# RETREAT AT TIMBERRIDGE FILING NO. 2

# CONSTRUCTION DRAWINGS

Engineering Review  
12/10/2021 1:20:54 PM  
dsdrice  
JeffRice@elpasoco.com  
(719) 520-7877  
EPC Planning & Community  
Development Department

**FALCON NEST COURT WEST CUL-DE-SAC EOA PROFILE**

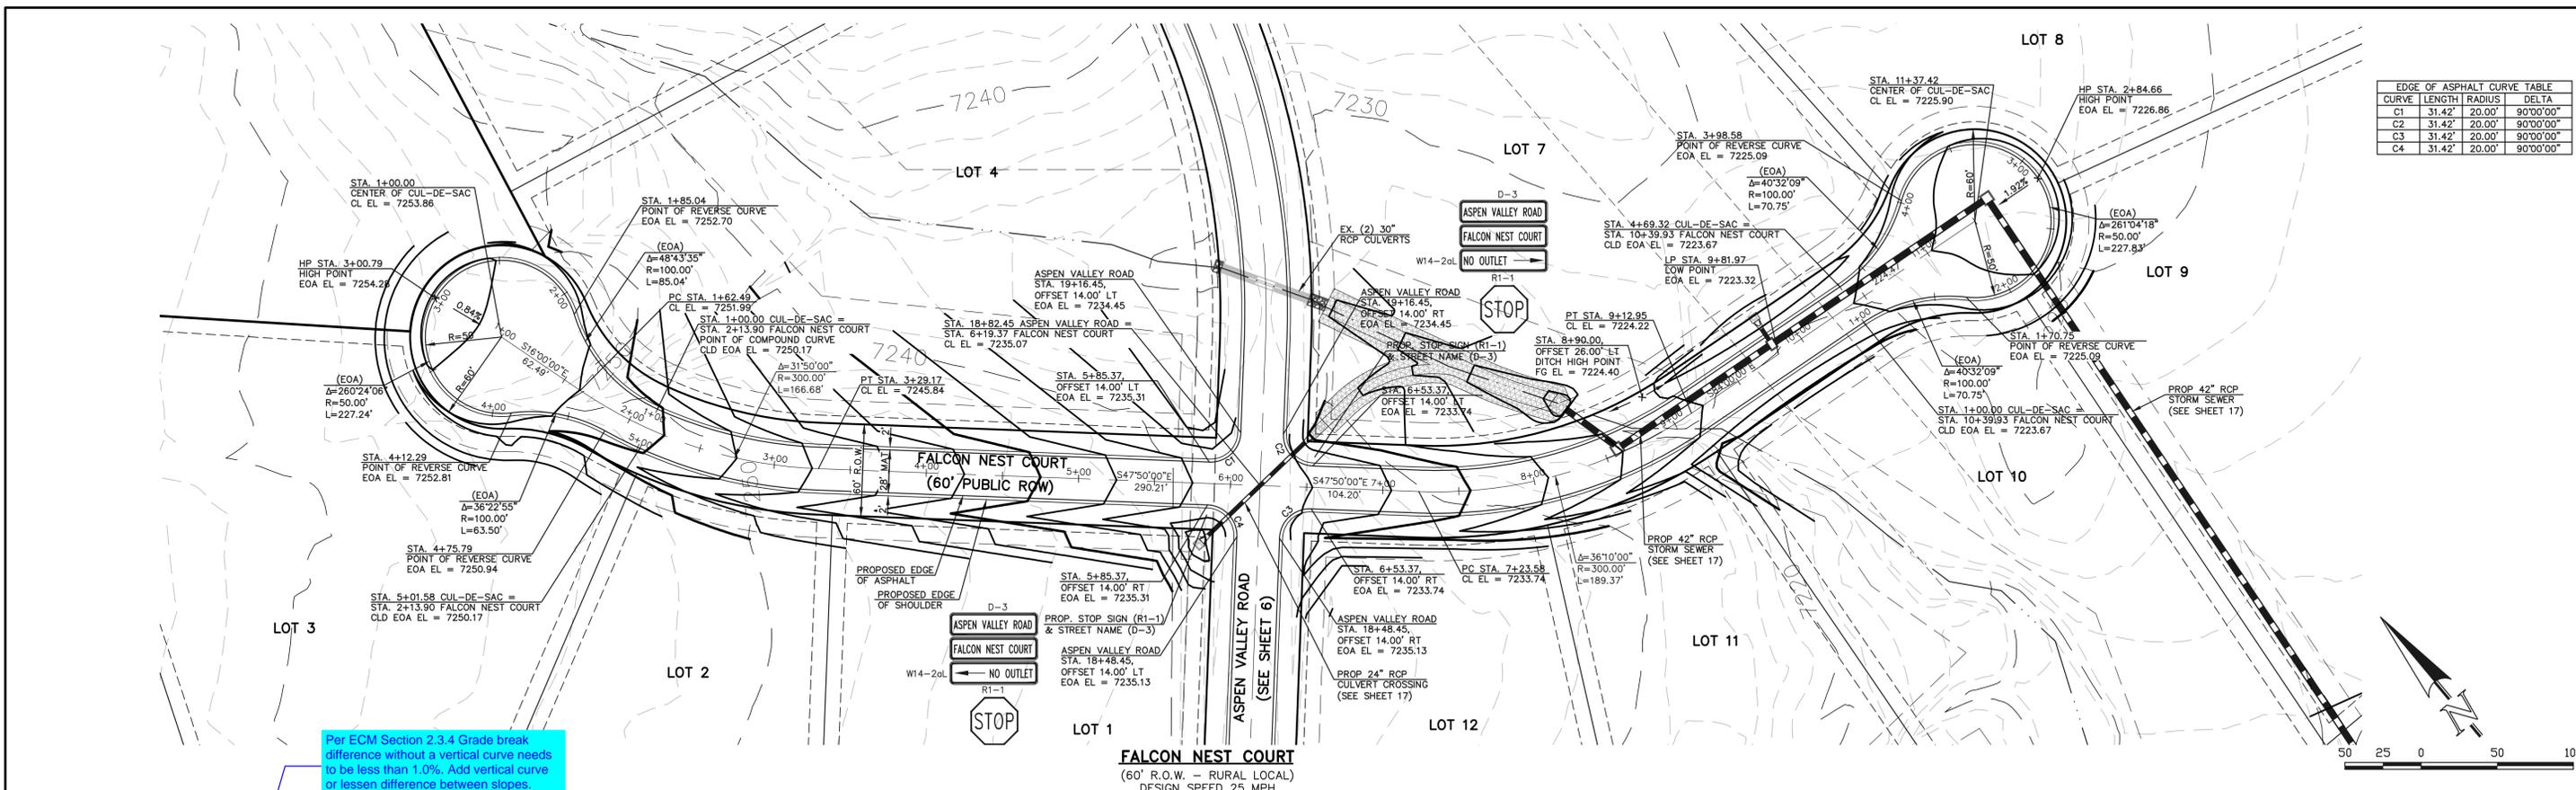
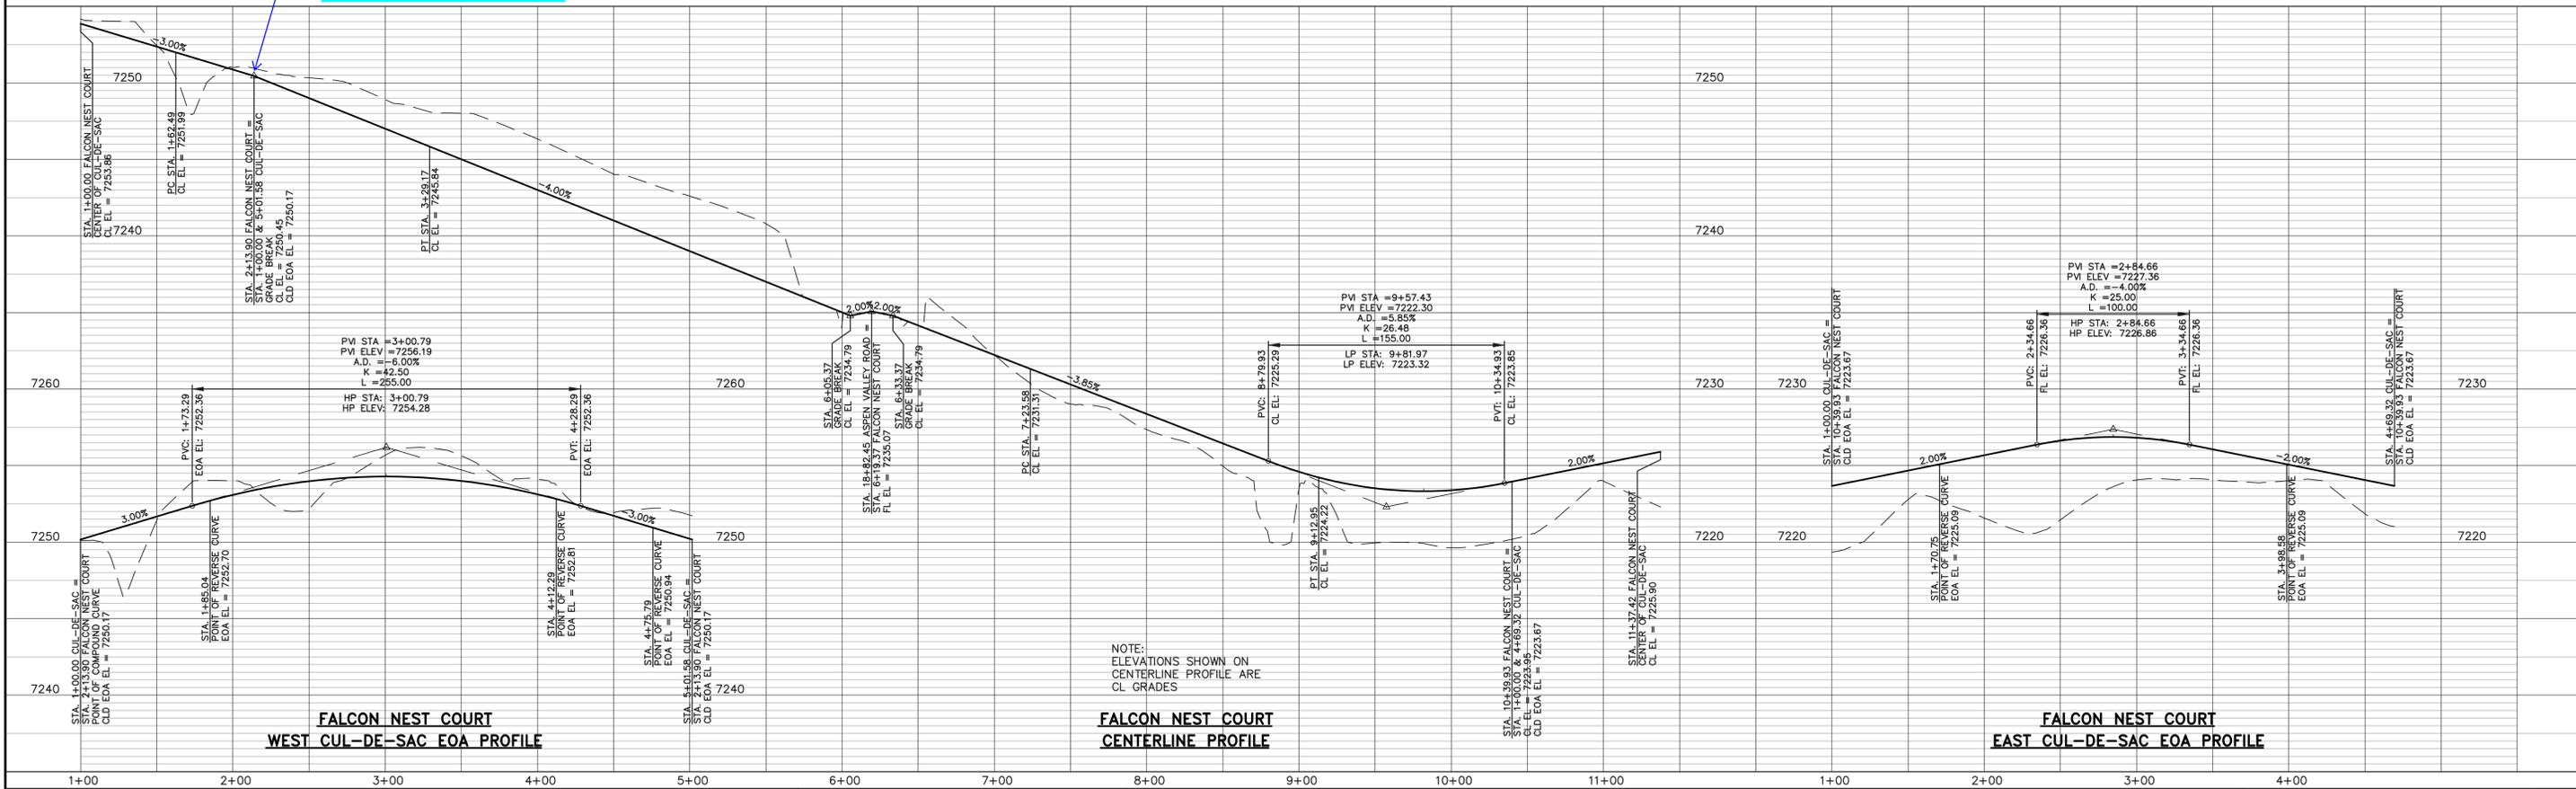
Per ECM Section 2.3.4 Grade break difference without a vertical curve needs to be less than 1.0%. Add vertical curve or lessen difference between slopes.

DETENTION POND 3 STORM SEWER OUTFALL  
(PUBLIC)

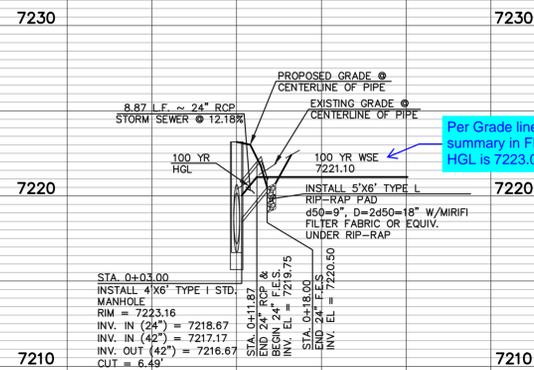
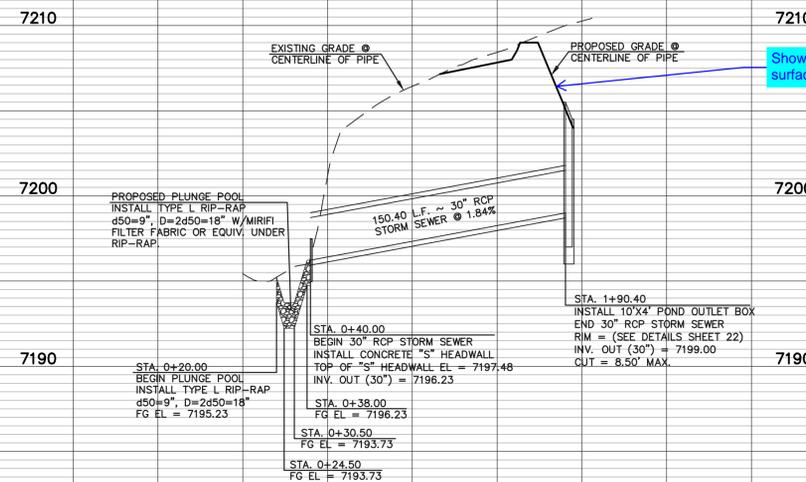
Per Grade line summary in FDR  
HGL is 7223.05

Show 100-year water surface

**FLOODPLAIN WIDENING & SELECTIVE BANK STABILIZATION**

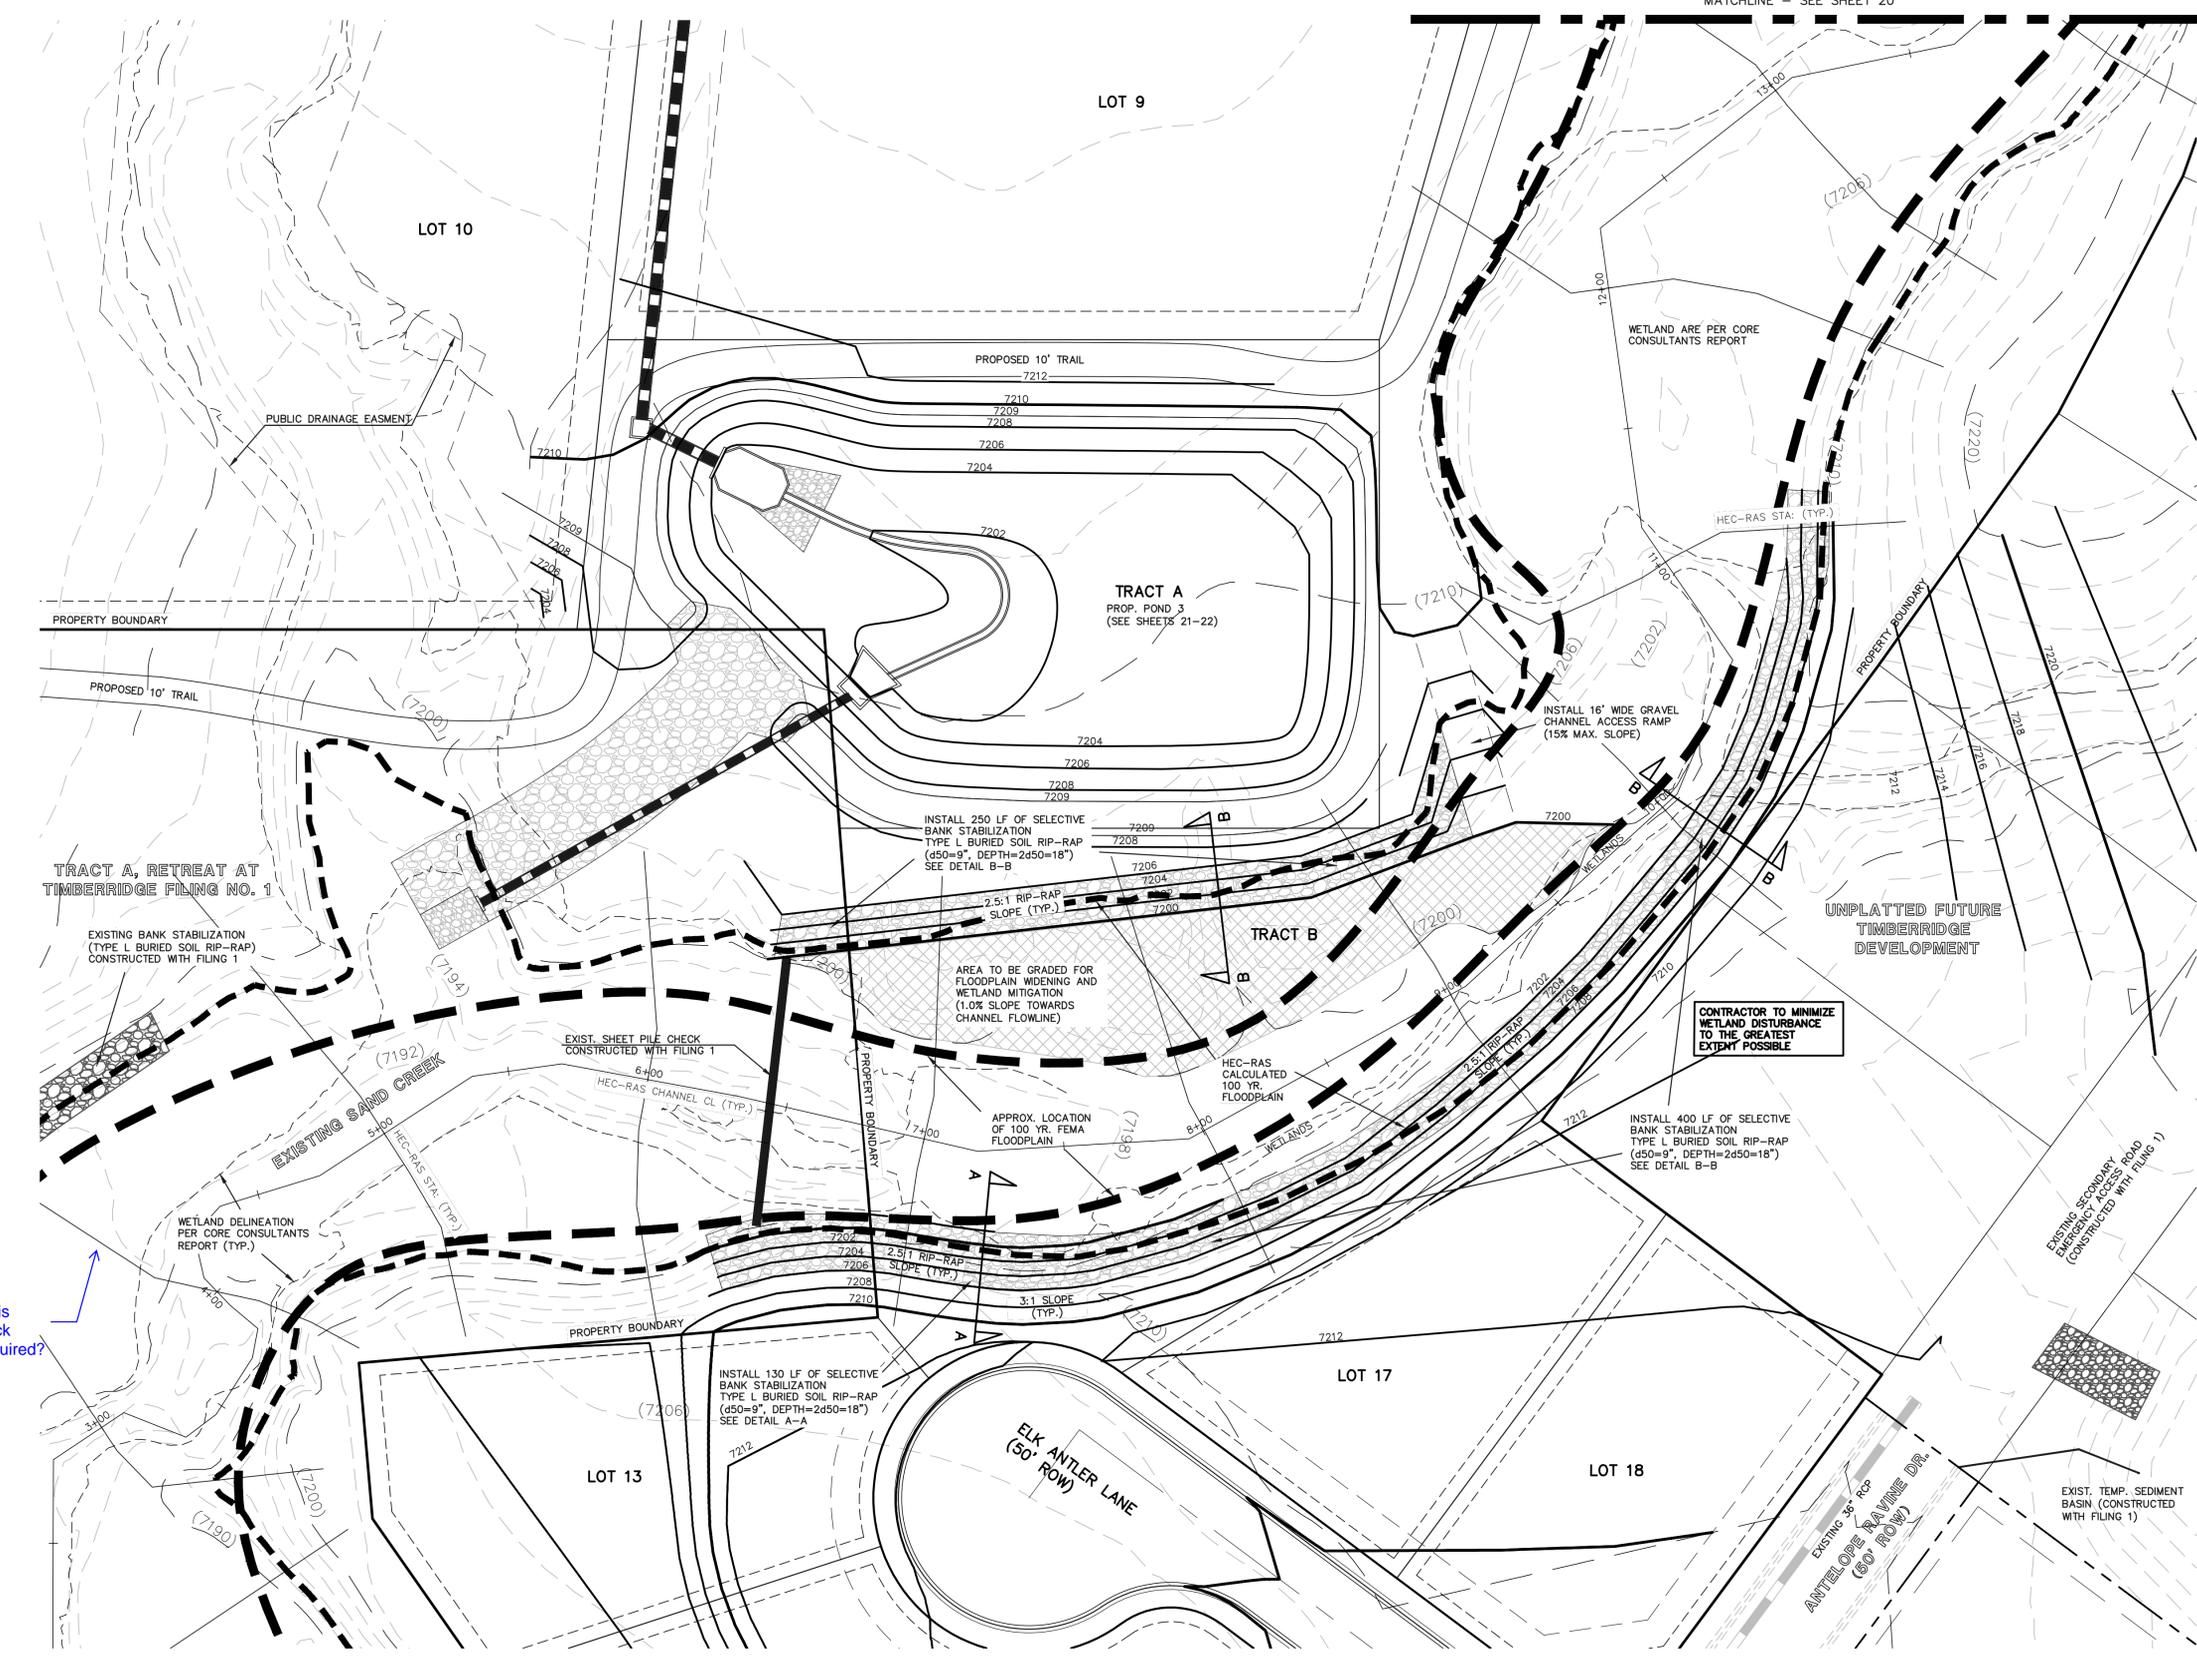
See FDR comments - is another check structure required?

RETREAT AT TIMBERIDGE FILING NO. 2  
CONSTRUCTION PLANS  
DETENTION FACILITY POND 3  
POND PLAN

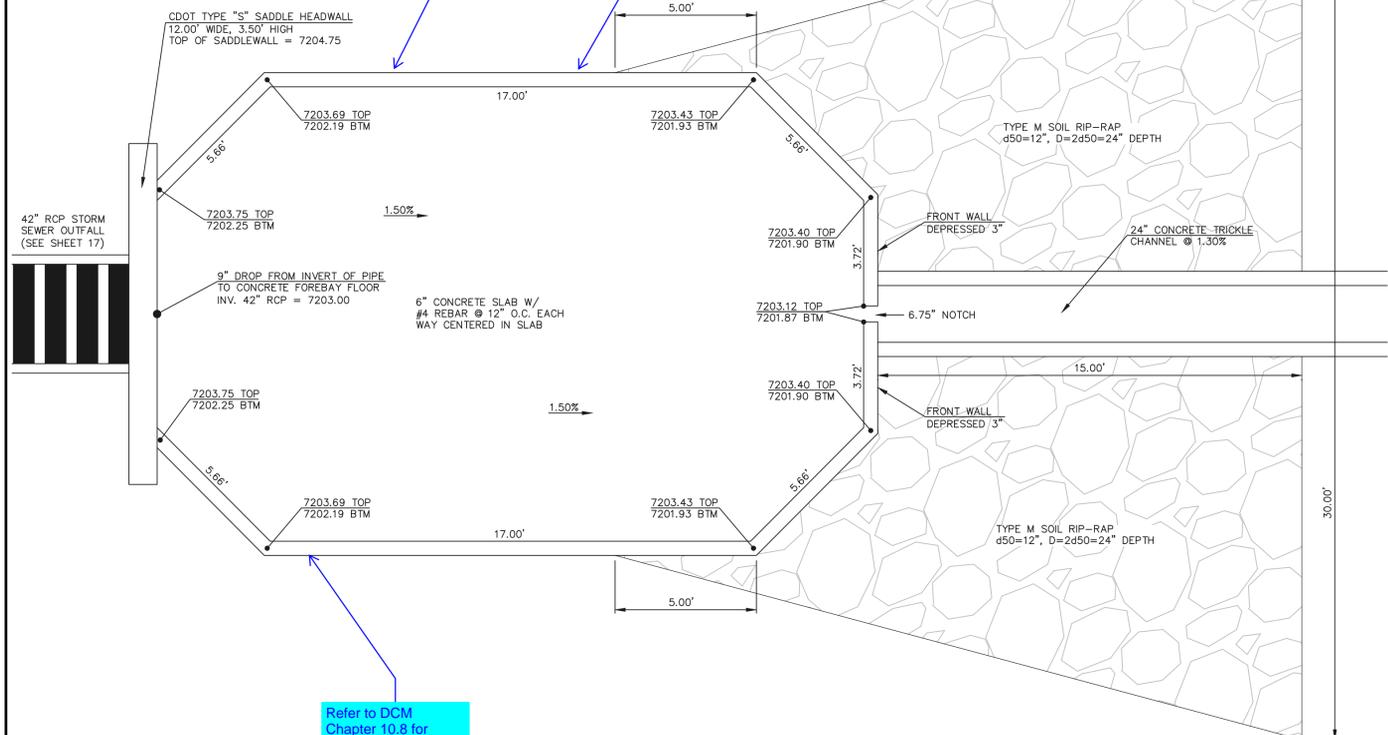
Include detail for maintenance access road

Access needs to be within 20 ft of all pond structures

provide a cutoff wall

Label railing

Provide roadway detail/cross section, including stone sizing and gradation.
